Appendix 2: Internal and External Consultee Representations

Carbon Management Team	<p>Carbon Management Response 21/12/2021</p> <p>In preparing this consultation response, we have reviewed:</p> <ul style="list-style-type: none"> • Energy and Sustainability Statement (Parts 1-3) prepared by (dated October 2021) • Outline Whole Life Carbon Report, prepared by Buro Happold (dated October 2021) • Detailed Whole Life Carbon Report Plot A, prepared by Buro Happold (dated October 2021) • Outline Circular Economy Statement, prepared by Buro Happold (dated October 2021) • Detailed Circular Economy Statement, prepared by Buro Happold (dated October 2021) • GLA carbon emission reporting spreadsheet • Relevant supporting documents. <p>1. Summary</p> <p>The development achieves a reduction of 44% carbon dioxide emissions on site overall, which is supported in principle. This will be achieved primarily through a connection to the Decentralised Energy Network.</p> <p>The detailed element of the hybrid application (Plot A) is proposed to reduce emissions by 91% overall, which is supported in principle. However, this plot does not fully comply with Policy SI2(B), which will need to be addressed. I

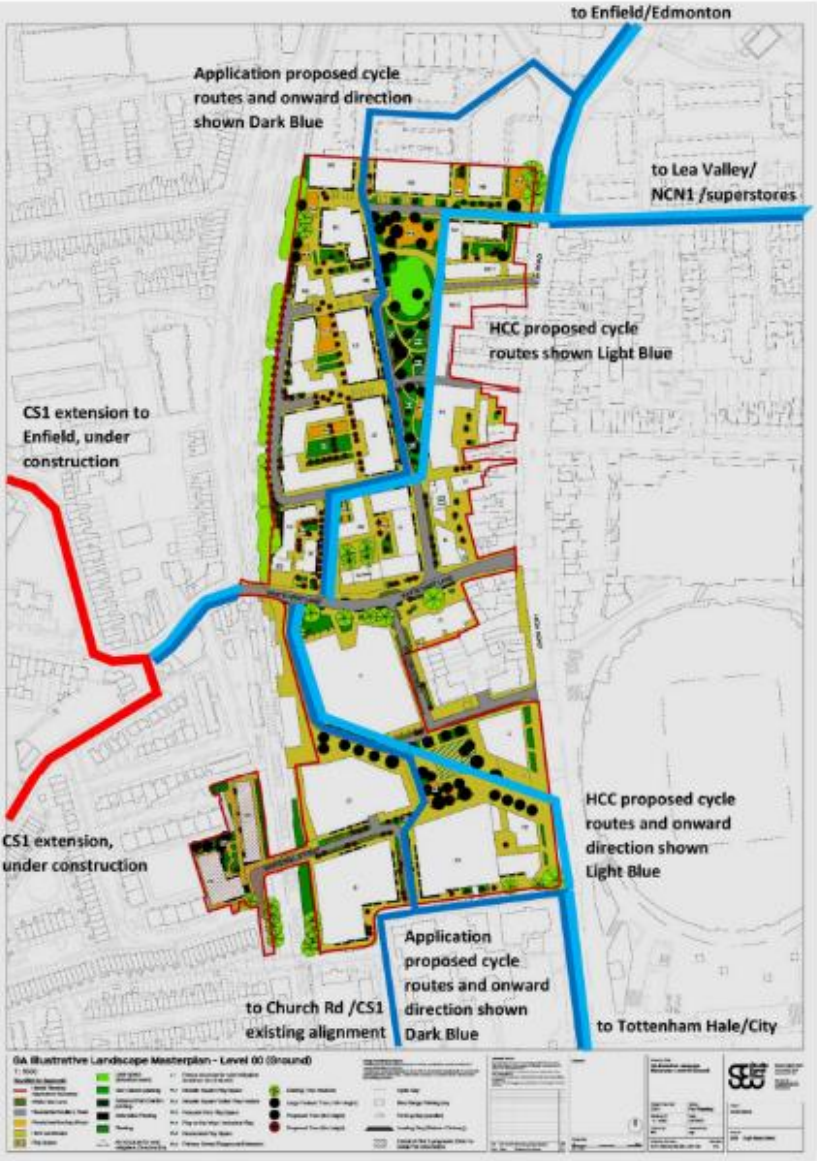
Environment Agency	<p>We understand that it is deemed not feasible to de-culvert the Moselle Brook as part of this application which you are in agreement with because of the constraints and place making requirements associated mainly with the stadium and access. We can accept this justification.</p> <p>With this in mind, we believe that planning conditions could be invoked to ensure that the culvert is protected and fit for purpose for the lifetime of the development. We have discussed wording of these conditions with the applicant and if agreeable these planning conditions would enable us to remove our objection. Before confirming this position I need to discuss the planning conditions with my flood risk colleagues. I will have this discussion early next week and submit a more formal response on the matter by Tuesday.</p> <p>9.03.2022</p> <p>We previously responded to this application on 3 February 2022 (NE/2022/134143/01- L01). At this time we objected to the application because the proposals missed the opportunity for de-culverting the Moselle Brook, designated main river, and did not provide an 8m undeveloped buffer zone from the edge of the culvert.</p> <p>We have since had discussions with yourself and the applicants agents regarding this objection. We have also received the following additional document:</p> <ul style="list-style-type: none"> • Design Note, EA Planning comments, 4202-RBG-ZZ-XX-DN-CV-01002 EA planning, 02.03/22, prepared by Robert Bird <p>We understand that it is unfeasible to de-culvert the Moselle Brook as part of this development because of other planning and place making requirements. It is also unfeasible to completely setback the development 8 metres from the Moselle Brook.</p> <p>Based on this we would be willing to remove our objection to the proposals subject to planning conditions.</p> <p>Condition 1- Culvert Condition Survey (pre-development)</p>	Suitably worded planning conditions are proposed to ensure that the proposal does not adversely impact on the existing culverted river.

Stakeholder	Comment	Response
	<p>For each Reserved Matters Application (RMA) adjacent to the Moselle Brook Culvert, a strategy for maintaining and improving the culvert should be submitted to, and approved in writing by, the Local Planning Authority. This strategy will include the following components:</p> <ol style="list-style-type: none"> 1. A line, level and condition survey of the existing culvert. The survey should demonstrate what the residual life of the culvert is. 2. A scheme, based on the condition survey in (1), to undertake any required improvements, repairs, or replacement of the culvert prior to the construction works. The scheme shall demonstrate how the culvert will be fit for purpose for the lifetime of the development (100 years). It should include a plan for any required long term monitoring and maintenance and a program for the improvements, repairs or replacement completion. <p>The scheme shall be fully implemented and subsequently maintained, in accordance with the scheme's timing/phasing arrangements, or within any other period as may subsequently be agreed, in writing, by the Local Planning Authority.</p> <p>Reasons To prevent flooding on site and elsewhere by ensuring that the Moselle Brook culvert is in satisfactory condition which is commensurate with the lifetime of the development. This condition is in line with the following national and local policies:</p> <ul style="list-style-type: none"> • Paragraph 163 of the NPPF 'When determining any planning applications, local planning authorities should ensure that flood risk is not increased elsewhere'. • Policy DM28 of the Haringey Development Management Development Plan Document (DPD) 'Where appropriate the Council will require proposals to include a condition survey of existing watercourse infrastructure to demonstrate that it will adequately function for the lifetime of the development, and if necessary, make provision for repairs or improvements.' <p>Condition 2 - Culvert Condition Survey (post-development)</p> <p>Within three months of completion of development blocks adjacent to the Moselle Brook and prior to the development plots being occupied (whichever comes first) an updated condition survey of the culvert, to identify any adverse impacts resulting from the construction works, shall be undertaken, submitted to, and approved in writing by the local planning authority. Any damage that may have arisen during construction is to be remediated by the applicant within an agreed timeframe.</p> <p>Reasons To ensure the structural integrity of the culvert is not compromised and to prevent flooding on site and elsewhere. This condition is in line with the following national and local policies:</p> <ul style="list-style-type: none"> • Paragraph 163 of the NPPF 'When determining any planning applications, local planning authorities should ensure that flood risk is not increased elsewhere'. • Policy DM28 of the Haringey Development Management Development Plan Document (DPD) 'Where appropriate the Council will require proposals to include a condition survey of existing watercourse infrastructure to demonstrate that it will adequately function for the lifetime of the development, and if necessary, make provision for repairs or improvements.'
